NEW MEXICO OIL CONSERVATION DIVISION
 - Engineering Bureau -
 1220 South St. Francis Drive, Santa Fe, NM 87505

ADMINISTRATIVE APPLICATION COVERSHEET

**RE: APPLICATION FOR ADMINISTRATIVE APPROVAL
OF UNORTHODOX WELL LOCATION
SAN JUAN 31-6 UNIT #6M WELL
UNIT K, W/2 SECTION 1-30N-7W
RIO ARRIBA COUNTY, NEW MEXICO**

Re: Administrative applications of Phillips Petroleum Company for an exception to the well location requirements provided within the "*Special Rules and Regulations for the Basin-Dakota Pool*," as promulgated by Division Order No. R-10987, as amended for the: (i) ~~San Juan "31-6" Unit Well No. 6-M~~ to be drilled 1615 feet from the South line and 2490 feet from the West line (Unit K) of Section 1, Township 30 North, Range 7 West, NMPM, Rio Arriba County, New Mexico, which was filed on June 21, 2001; and (ii) San Juan "29-5" Unit Well No. 54-M (API No. 30-039-26582) to be drilled 664 feet from the North line and 2543 feet from the West line (Unit C) of Section 31, Township 29 North, Range 5 West, NMPM, Rio Arriba County, New Mexico, which was filed on July 6, 2001.

San Juan 31-6 (Mesaverde)

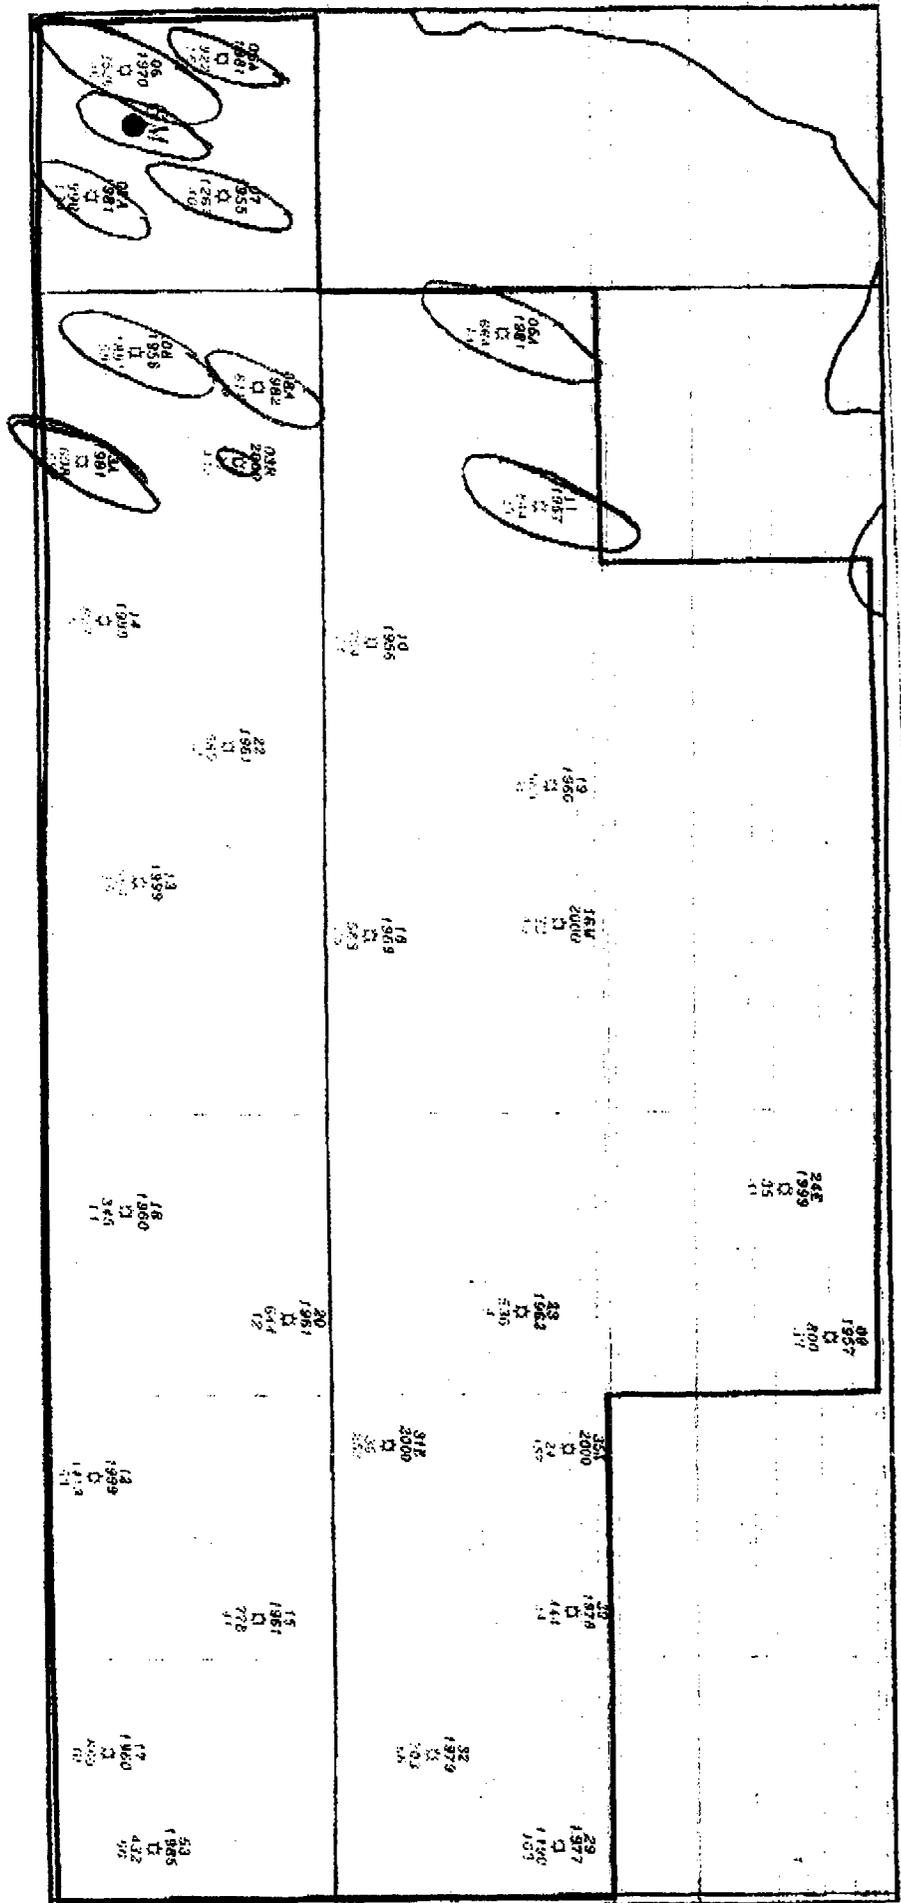
The Aztec district office of the Division and I have reviewed both applications, whereby both mentioned that "spacing of the Mesaverde infill to optimize drainage was considered"; however, no support data was included. In order to complete these filings please submit the necessary technical data to support this statement and indicate on a map how the drainage will occur from both wells.

I am unable to give an informed opinion on this application as the archeological argument is unsupported, as is the Mesaverde drainage pattern. Without access to the archeology, I can not judge the topographic reasons for the NSL.

Attached are the 31-6 Unit Mesaverde and 29-5 Unit Mesaverde cumulative production and daily rate maps. The drainage patterns were estimated using a 3 to 1 pattern 10° East of North. As a Unit operator, it is in Phillips and our partners best interest to pick locations that best drain the dedicated acreage. The 29-5 #54M and 31-6 #6M are planned to be Dakota/Mesaverde commingles. These wells were staked in Non Standard locations in the Dakota due to archeology and topographic restrictions.

The maps give reasonable geologic data to back up the topo and archeological reasons that we looked at last week on these NSLs.

Overall, I think they are justified.
